ITEM: 6.13	REPORT SUMMARY MINOR VARIANCE APPLICATION FILE NUMBER A166/23
-------------------	--

MINOR VARIANCE APPLICATION FILE NUMBER A166/23

CITY WARD #:	1
APPLICANT:	Gerardo C. Borean
AGENT:	Stella Arcuri
PROPERTY:	38 Corkwood Crescent, Maple
ZONING DESIGNATION:	See below.
VAUGHAN OFFICIAL PLAN (2010) DESIGNATION:	Vaughan Official Plan 2010 ('VOP 2010'): "Low-Rise Residential".
RELATED DEVELOPMENT APPLICATIONS:	None
PROPOSAL:	Relief from the Zoning By-law is being requested to permit two accessory structures (three-sided lean-to shelter and prefabricated shed) and outdoor swimming pool (hot tub) located in the rear yard.

SCHEDULE A: DRAWINGS & PLANS

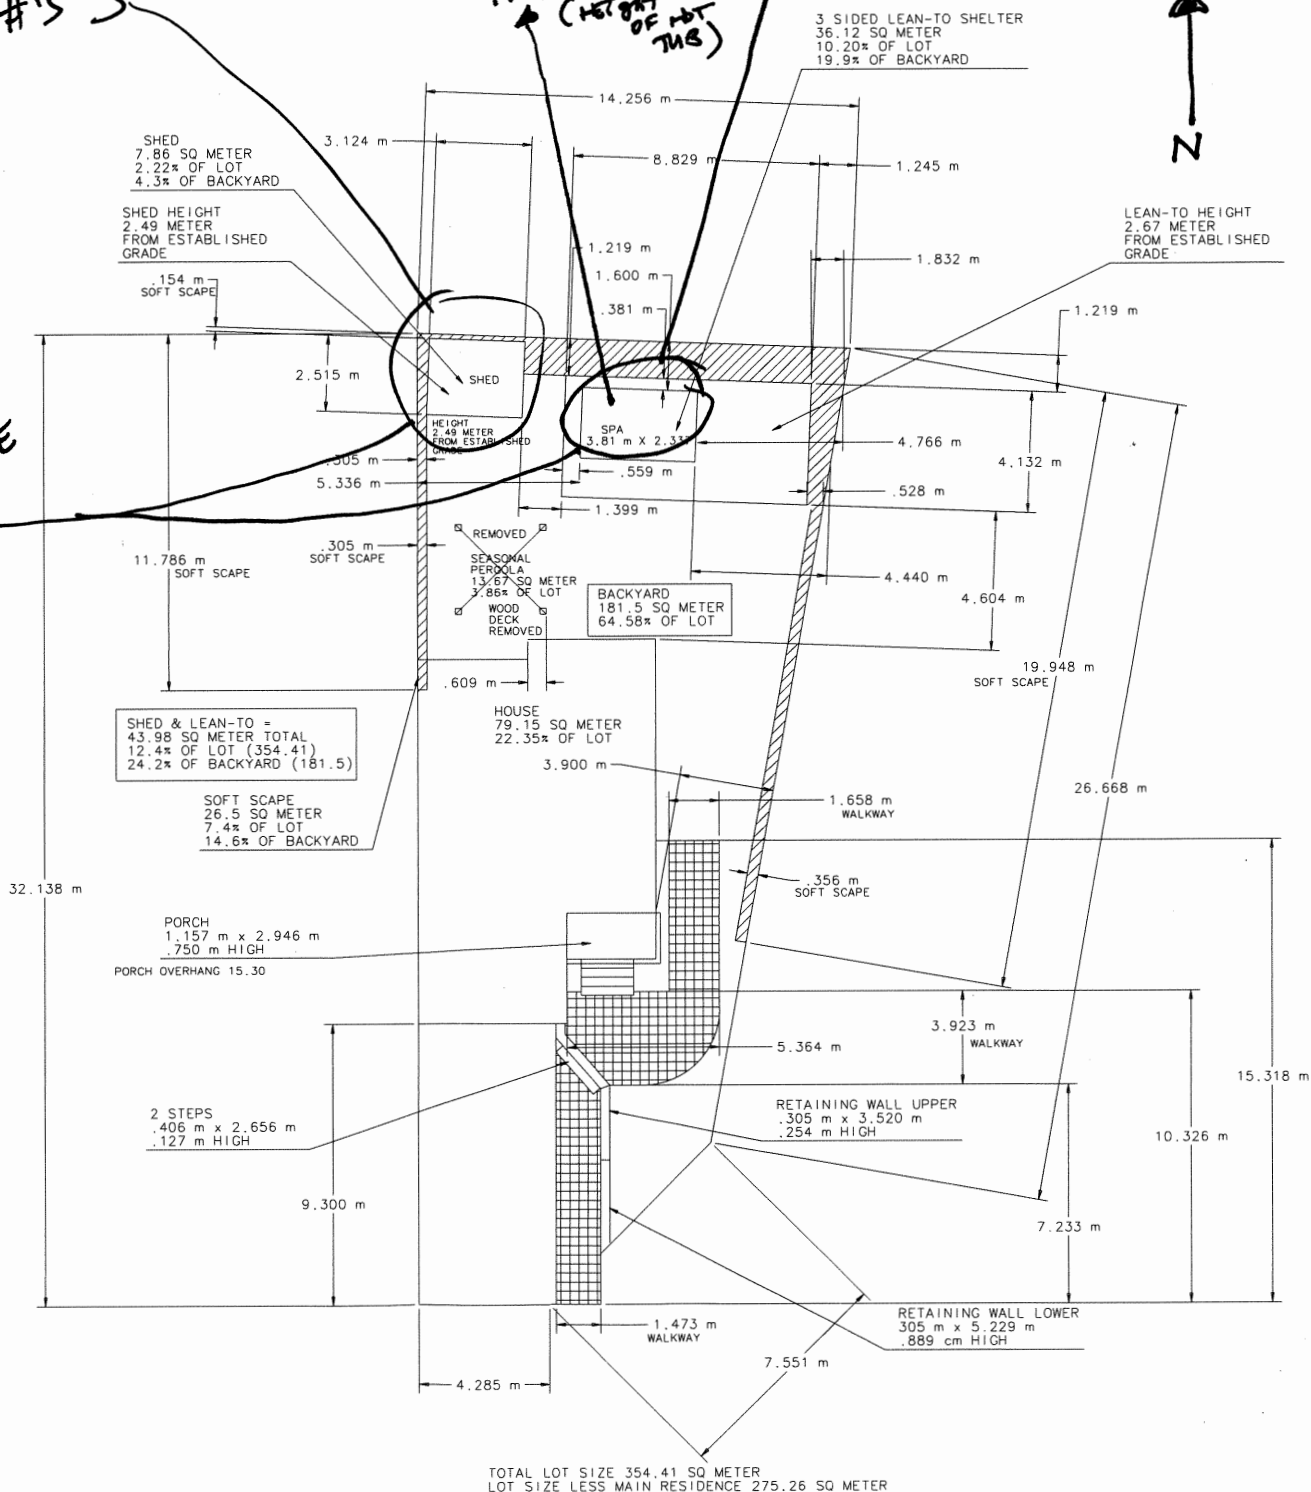
General Comments	
1	The Applicant has crossed off the seasonal pergola from the Site Plan, noting that it has been removed.
2	The Applicant confirms that the wood deck from the Site Plan has been removed, as noted on the Site Plan.
3	The Applicant confirms that the height of 2.67 m for the residential accessory structure (three-sided lean-to shelter) and the height of 2.49 m for the residential accessory structure (prefabricated shed) are measured from established grade, as noted on the Site Plan. Elevation drawings for building permit, however, must specifically note same.
4	Drawings submitted for building permit and minor variance application shall match.
5	The applicant shall be advised that additional variances may be required upon review of detailed drawing for building permit.
6	Zoning review of the subject lands is limited to the lot. It appears that the walkway as shown on the Site Plan may extend into municipally owned property. The Applicant should consult with the Clerk's Department regarding encroachment agreements.

The Development Planning Department has no objection to Variances 1, 2, and 5. The Subject Lands are a corner lot with an angled exterior side lot line that creates a pie shape. The three-sided lean-to shelter is in the northeast corner where the lot is at its widest point. The lean-to shelter is also located closer to the exterior side lot line than the principal dwelling. The shelter presently contains a hot tub and a small bar area. The bar area is located closer to the east wall of the shelter. A sizeable portion of the exterior side yard abutting the rear yard is fenced and functions as part of the rear yard's amenity area. This moves the dividing line between the street-oriented front yard space and more private rear yard space further south, creating more spatial separation between this dividing line and the south wall of the lean-to shelter. This added separation helps mitigate the prominence of an accessory structure that is closer to the exterior side lot line than the dwelling. There is sufficient spatial separation between the shelter and fence along the exterior side lot line to permit maintenance access and drainage. The shelter is of modest height at 2.7 m and is not anticipated to have adverse massing

impacts to the neighbouring properties or road. The location of the shelter and hot tub within it does not pose any encumbrances to the function of the rear yard or the street. The fence assists in buffering any use impacts that the shelter and hot tub may generate. There is sufficient distance between the shed and exterior lot line to permit access maintenance. The abutting property Owners (#36, #72, #76 Corkwood Crescent) have provided acknowledgement letters stating they have not experienced any adverse grading/drainage effects on their properties and have no objection to the presence of the shelter.

The Development Planning Department has no objection to Variances 3 and 4. The shed is in the northwest corner of the rear yard, is of modest height measuring 2.49 m to the peak of the shed's roof. The setback of 0.15 m provides limited space for access maintenance, if required. The abutting property Owners (#36, #72, #76 Corkwood Crescent) have provided acknowledgement letters stating they have not experienced any adverse grading/drainage effects on their properties and have no objection to the presence of the shed. With respect to Variance 4, the shed and shelter have reasonably sized footprints. The shed has an area of 7.86 m², or 2.22% of the total lot coverage. The shelter has an area of 36.12 m², or 10.20% of the total lot coverage. Both accessory structures combined only accounts for 12.42% of the total lot coverage, which is minimal in nature. The requested relief for an additional 8.58 m² lot coverage for all accessory structures is not perceptible.
